ZONING BOARD OF APPEALS MEETING

LOCATION: TOWNSHIP ANNEX, 7527 HIGHLAND ROAD, WHITE LAKE, MICHIGAN 48383
THURSDAY, DECEMBER 14, 2023 – 7:00 PM

TO: Zoning Board of Appeals
FROM: Justin Quagliata, Staff Planner
DATE: December 14, 2023

Planner's Report

WEST SIDE ELEVATION SCALE: 1/4" = 1'-0"

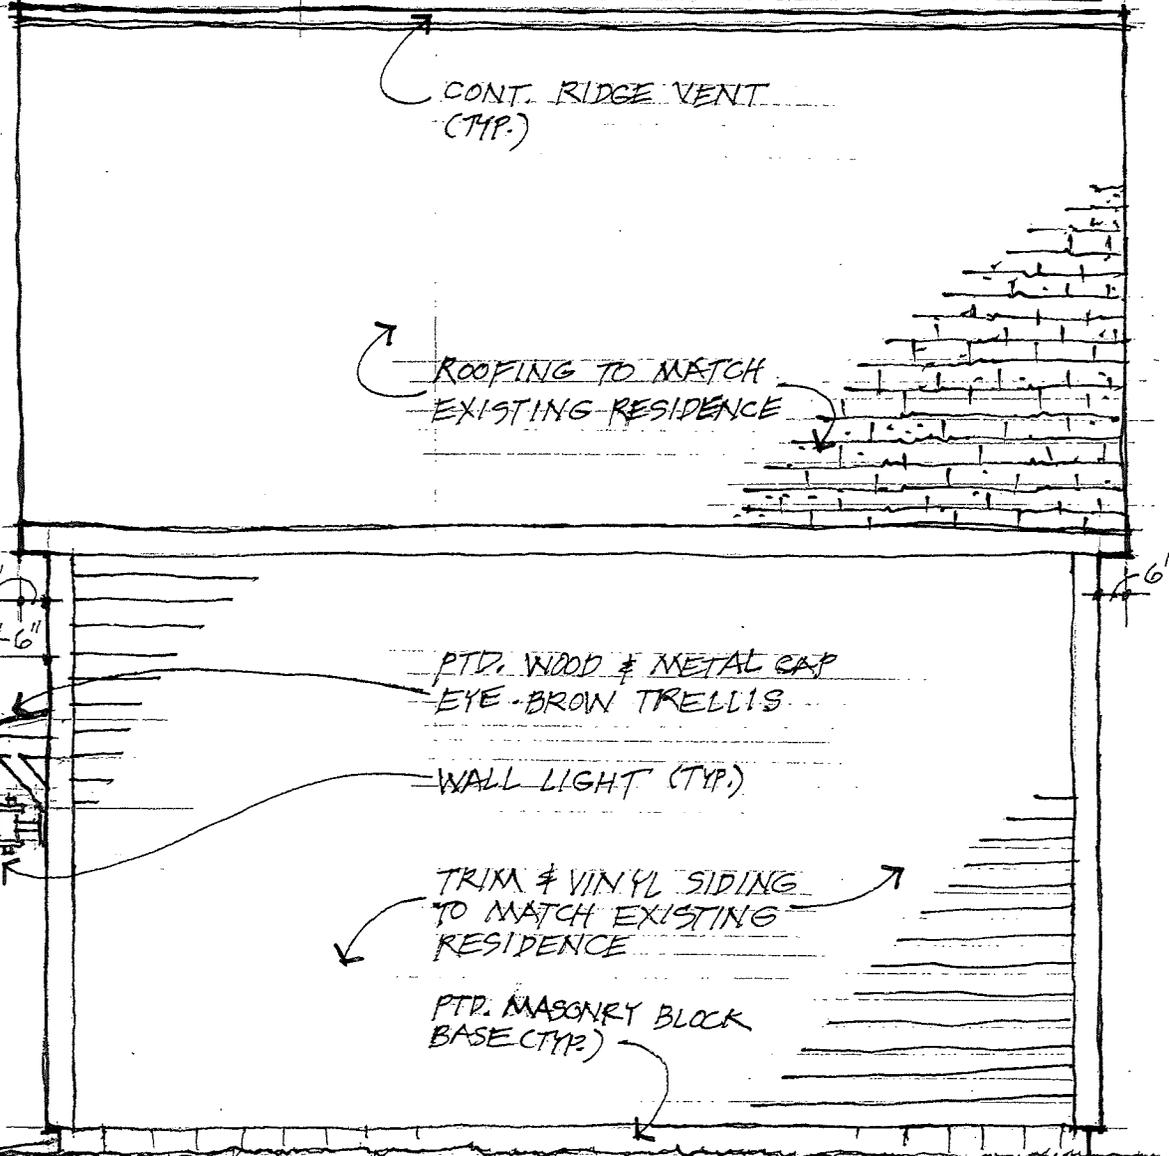
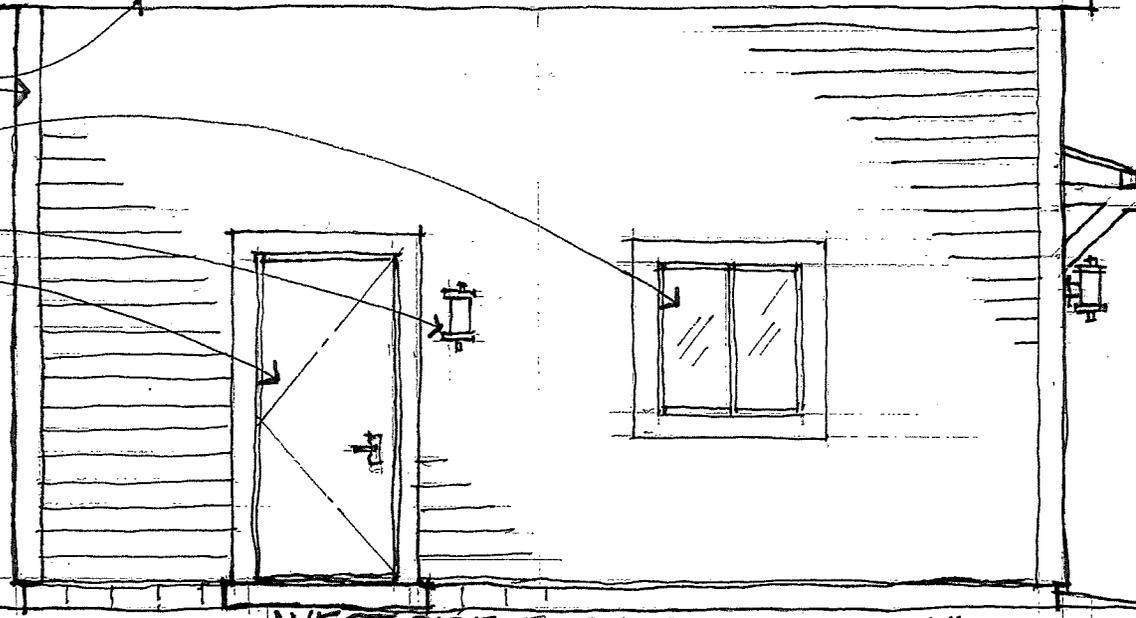
Per the submitted architectural plans, the roof overhang on the accessory building is proposed to extend one foot beyond the side walls (located 4.5 feet from the south side property line). Section 5.3 of the Zoning Ordinance prohibits roofs, gutters, windows, and open balconies from projecting closer than five feet to a lot line. The proposed roof overhang would not be permissible if the requested variance is granted; the architectural plans would need to be revised to reduce the overhang on the south side.

- The Applicant shall obtain all necessary permits from the White Lake Township Building Division.
- A foundation certificate shall be required prior to the backfill inspection by the Building Division.
- An as-built survey shall be required to verify the approved setbacks.
- In no event shall the projection of any roof overhang be closer than five feet to the side lot lines. Revise the architectural plans to reduce the overhang on the south side.
- The architectural plans shall be revised to show removal of the proposed dormer and reduction in building height to comply with the Zoning Ordinance.

SOUTH ELEVATION

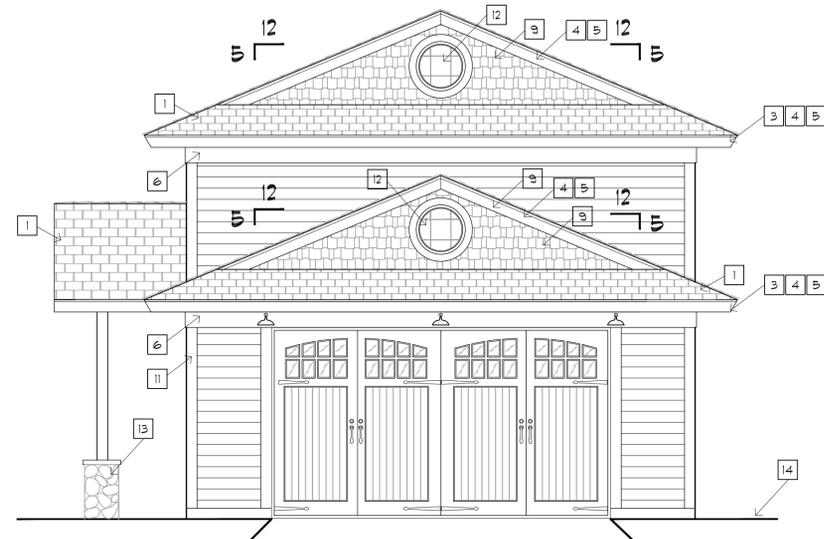
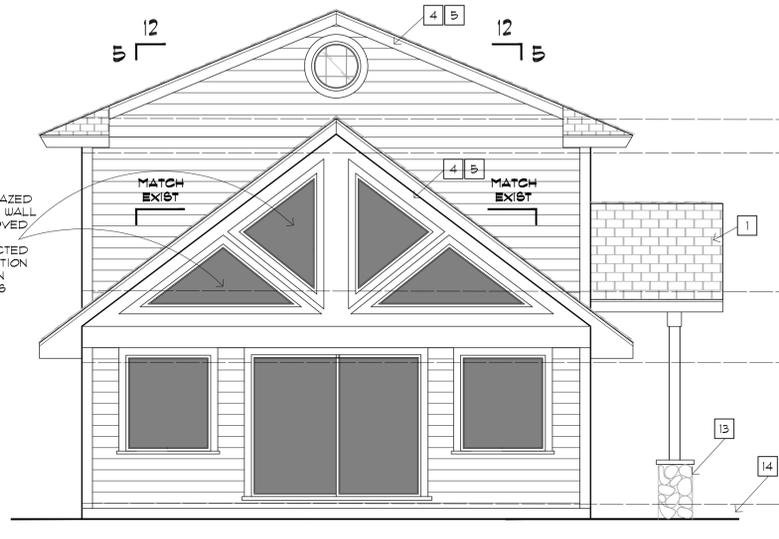
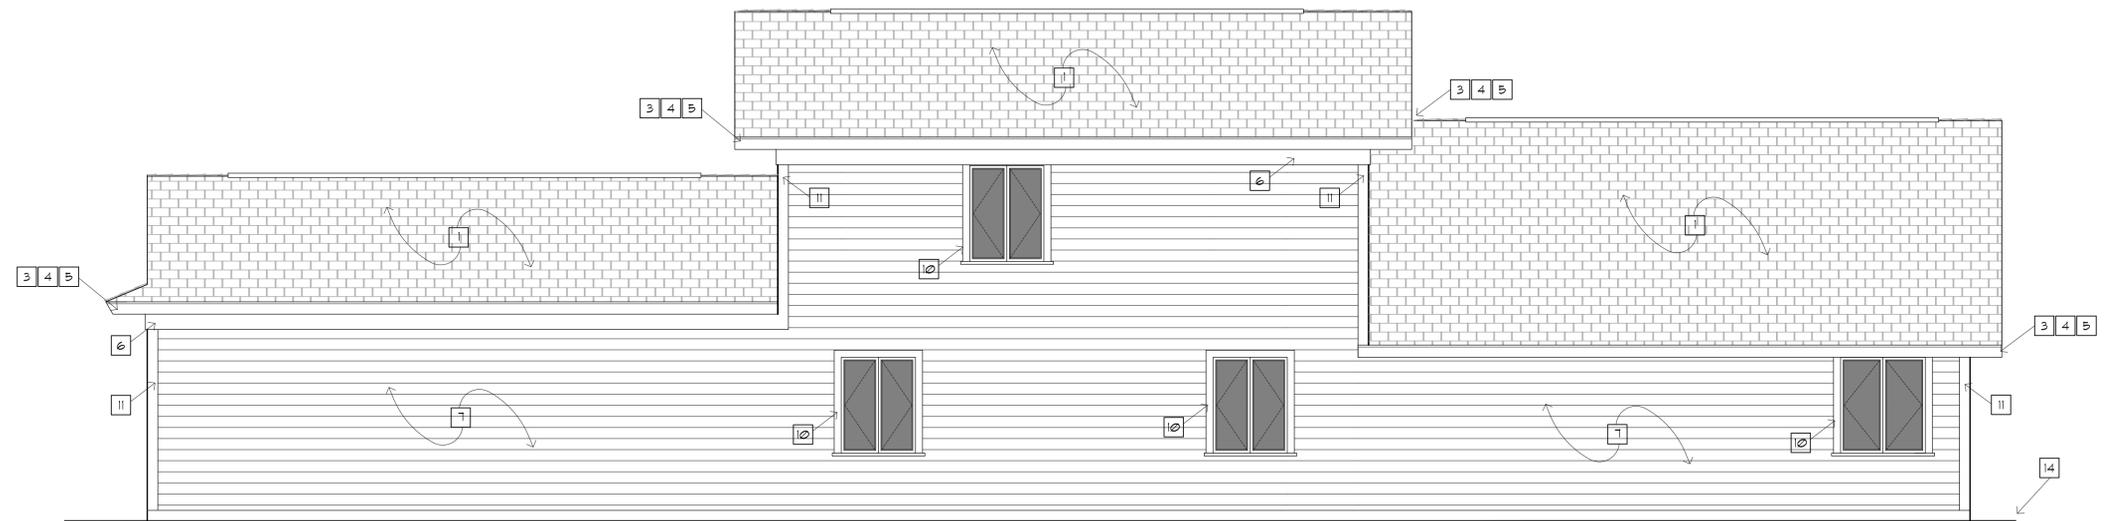
The submitted architectural plans show a proposed covered porch extending approximately four-six feet (extent of projection not dimensioned/labeled on the plans) off the west side of the building. Section 7.27.vii of the Zoning Ordinance prohibits the Zoning Board of Appeals from granting a variance to permit a setback of less than five feet from a side lot line to ensure access for fire equipment and other emergency vehicles. If the Board decides to approve the request, a condition must be revising the architectural plans to eliminate the proposed covered porch.

- The Applicant shall obtain all necessary permits from the White Lake Township Building Division.
- The Applicant shall resubmit architectural plans showing elimination of the proposed covered porch from the west side of the house.
- No mechanical units, including HVAC system or generator, shall be placed in the front yard or closer than five (5) feet to any side yard lot line or rear yard lot line.
- A foundation certificate shall be required prior to the backfill inspection by the Building Division.
- An as-built survey shall be required to verify the approved setbacks.
